REGULAR MEETING AGENDA

**Tuesday, July 23, 2024
6:30 P.M.**

1. CALL TO ORDER
2. ROLL CALL
3. APPROVAL OF THE MARCH 26, 2024, REGULAR MEETING MINUTES
4. APPROVAL OF AGENDA
5. PUBLIC HEARINGS
 - A. **SPECIAL LAND USE – WHITE WATER CAR WASH – 2675 WASHTENAW AVENUE – PACEL K-11-06-304-004** – TO CONSIDER THE SPECIAL CONDITIONAL USE PERMIT APPLICATION OF EROP, LLC TO PERMIT THE CONSTRUCTION OF A 6,820 SQ. FT. CAR WASH FOR A 1.55-ACRE SITE ZONED RC, REGIONAL CORRIDOR, WITH A PROPOSED SITE TYPE C DESIGNATION.

6. OLD BUSINESS
7. NEW BUSINESS
 - A. **PRELIMINARY SITE PLAN – WHITE WATER CAR WASH – 2675 WASHTENAW AVENUE – PACEL K-11-06-304-004** – TO CONSIDER THE PRELIMINARY SITE PLAN APPLICATION OF EROP, LLC TO PERMIT THE CONSTRUCTION OF A 6,820 SQ. FT. CAR WASH FOR A 1.55-ACRE SITE ZONED RC, REGIONAL CORRIDOR, WITH A PROPOSED SITE TYPE C DESIGNATION.

CONIFEROUS TREE PLANTING DETAIL

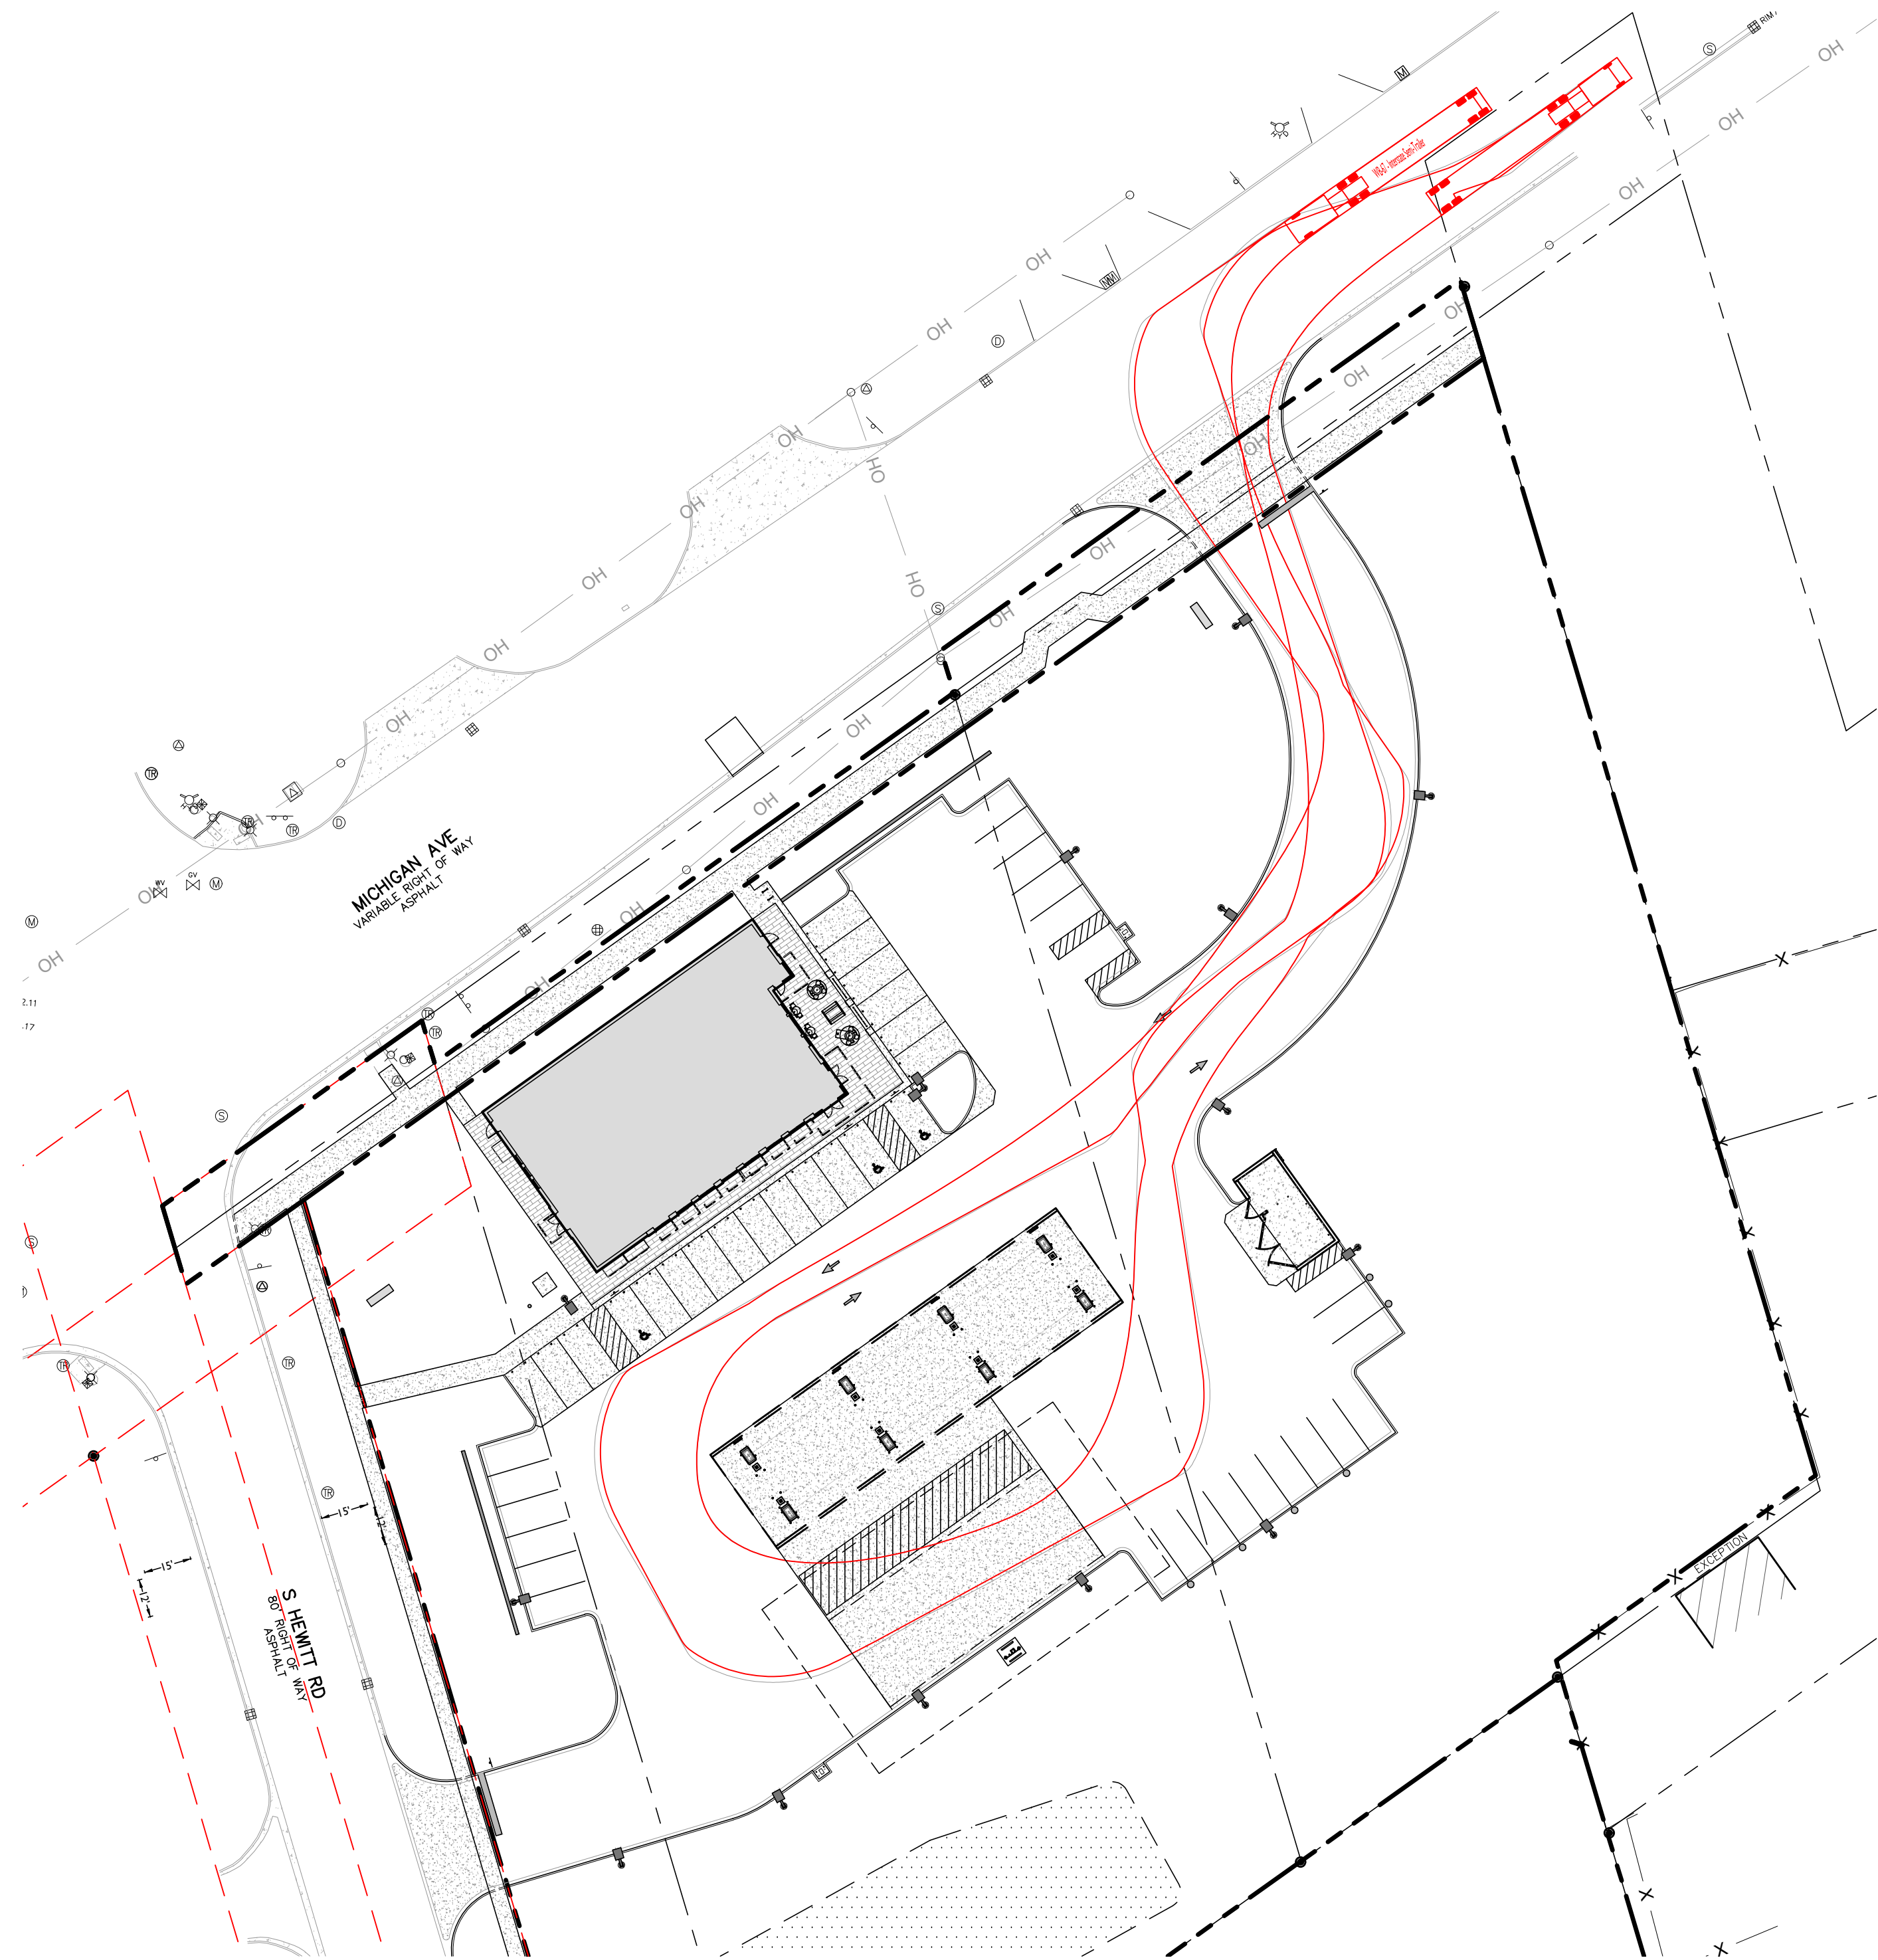
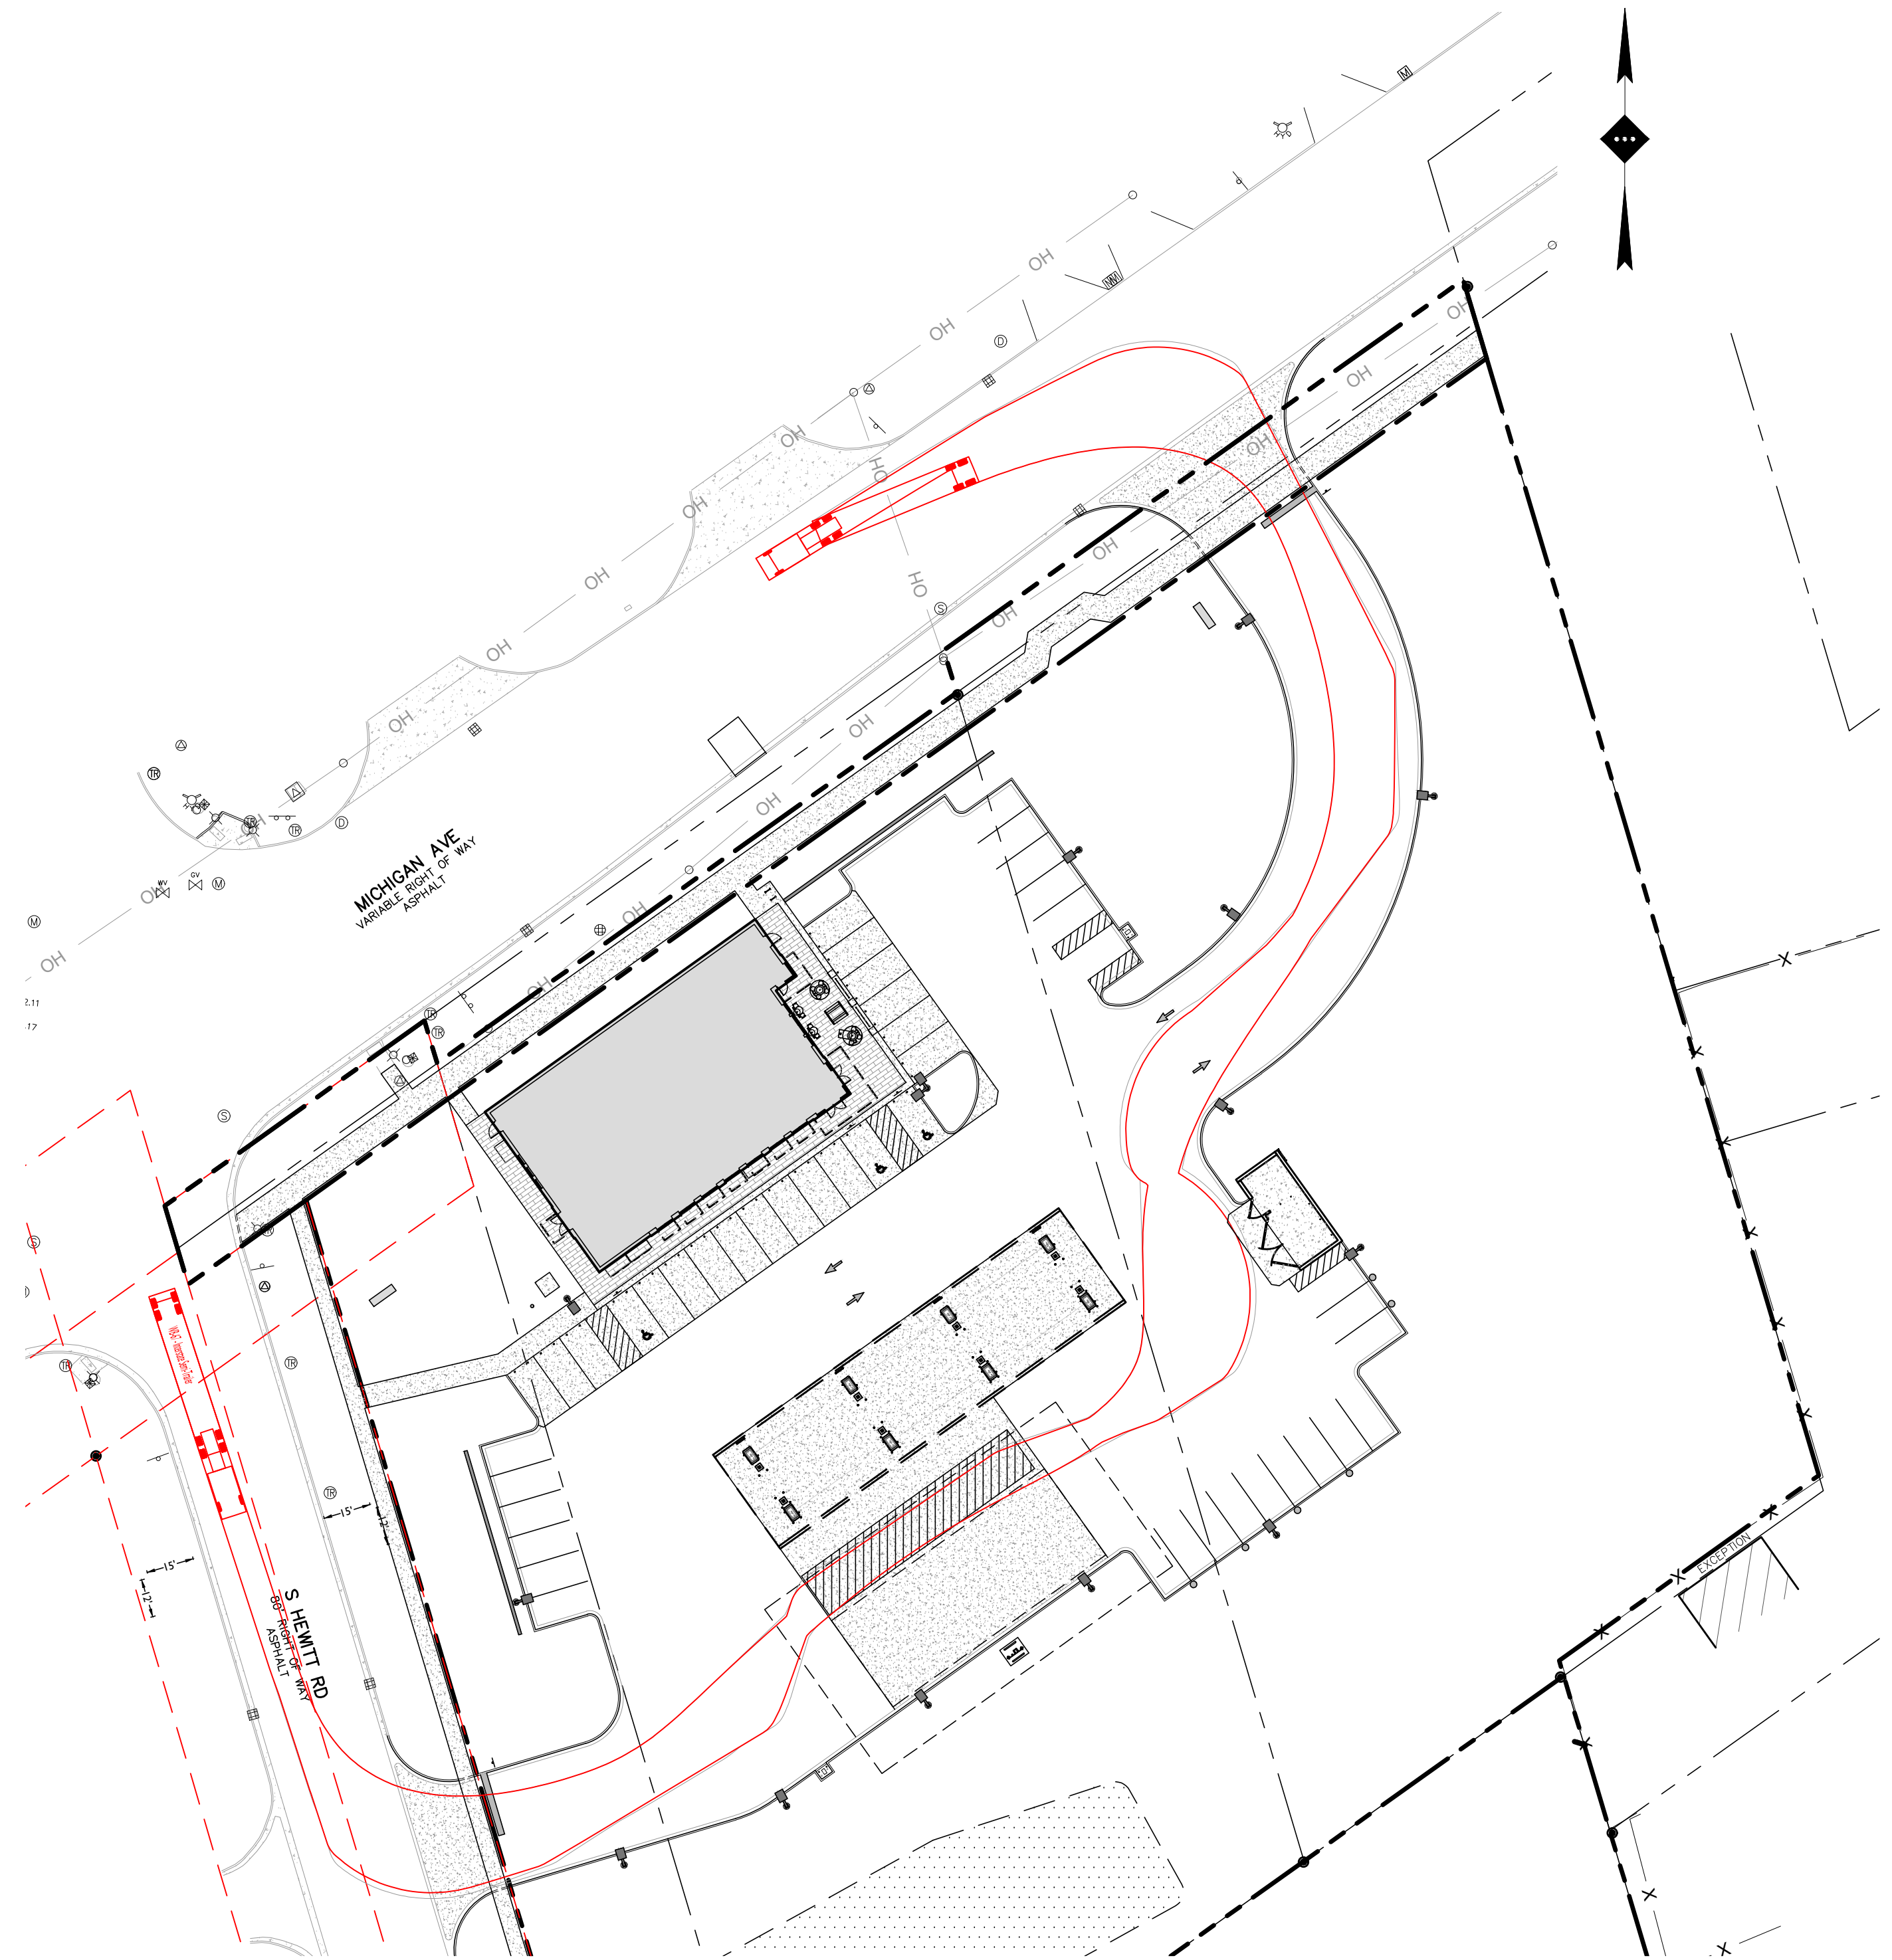
Sheets C-6 and C-7 show turning movements of various truck types (delivery, tanker, trash and fire). All of these vehicles can make the turning movements around the gas-pump canopy. One observation we have is that the easterly position of the canopy makes the tanker truck movements a little tight. The canopy could be shifted to the west to give the tanker more space to make this movement, while still providing enough space for users of the west parking spaces to access and exit these spaces. The Planning Commission may want to discuss this with the applicant.
